ATTACHMENT D

February 13, 2019

Subject: Change of Soil Engineer of Record
Response To Correction Letter And Report Update
Proposed Mixed-Use Eight Story Building With Seven Residential Floors
On Top Of One Level Of Office and/or Retail Space
With Two Levels of Subterranean Parking
Tract: 5273, M B 55-52
Lot: 38,39,40,41,42,43,44,45,46,47,48
625-665 S. La Brea Avenue
Los Angeles, California

SOILS REPORT REVIEW LETTER

Table 1: Basement Wall Design with Hydrostatic Pressure

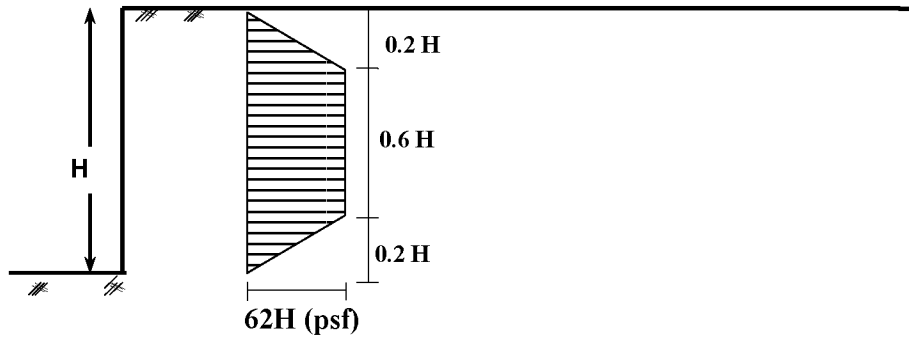
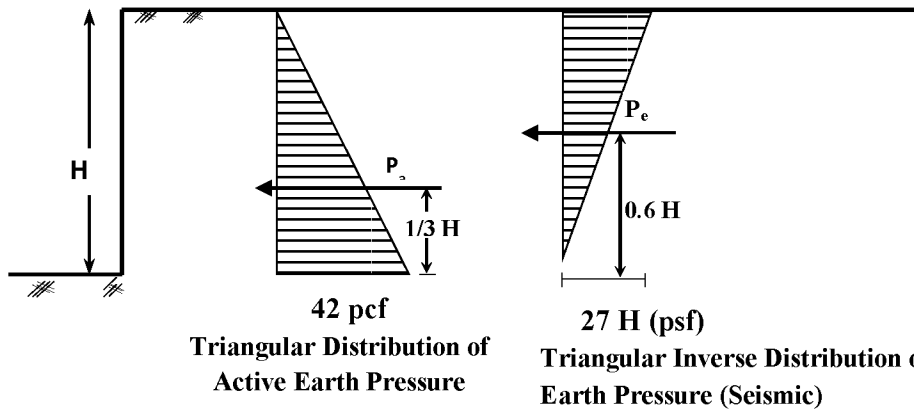
1. We have revised our recommendations to provied hydrostatic and uplift pressure for the proposed building's basement walls, and mat foundation. Permanent dewatering has been abandoned for this project.
2. In the original soils report extensive dewatering was recommended due to three levels of subtranian, now with reduction to proposed two levels of subtranian

1. Due to the level of ground water encountered, permanent dewatering is not approved for the proposed project. Revise recommendations for the proposed foundation to be designed for hydrostatic uplift.
2. Provide an evaluation of the potential settlements of adjacent foundations due to the effects of temporary dewatering.

1. Restrained Wall Design Based on At Rest Earth Pressure plus Hydrostatic Pressure

- Restrained Subterranean walls**, “walls for which horizontal movement is restricted at the top”, shall be designed for an At-Rest lateral earth pressure (equivalent fluid weight) as illustrated in the above diagram of **Trapezoidal Distribution of Earth Pressure, 62H(psf)**. Our analysis of restrained and cantilevered retaining walls indicate that load combination of seismic plus static active is lower than the at-reat forces. Therefore, no additional loading due to seismic is required for restrained walls.
- Cantilevered retaining walls** higher than 6 feet shall be designed with the addition of seismic surcharge as illustrated on the above diagrams of Triangular Distribution of Active Earth Pressure and Triangular Inverse distribution of seismic pressure.

Table 2: Shoring Design

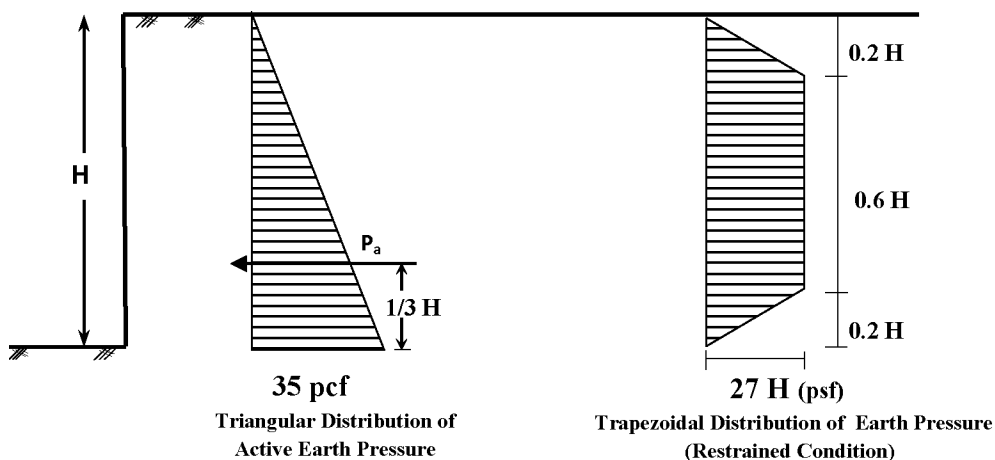
1. the number of subterranean levels in the original soils report was proposed to be three levels. Only two level of subterranean are proposed now. Therefore, their maximum depth of excavation for the construction of the proposed subterranean parking will be reduced by some ten feet.
2. The hight of the building above the subterranean levels has been reduced from eleven stories to eight stories.
3. Addition of a lot number 38 to the north end of the project.

For our revised temporary shoring recommendation see Table 2 shoring design and the diagram in our attachments.

Shoring Design Based on Active Earth Pressure

Cantilevered soldier pile should be designed to resist an active earth pressure. The active earth pressure condition assumes that a triangular pressure distribution is utilized in the shoring design. If the soldier piles are not allowed to deflect, they shall be designed for the Restrained Condition. Soldier piles designed for the restrained condition should utilize a trapezoidal pressure distribution.
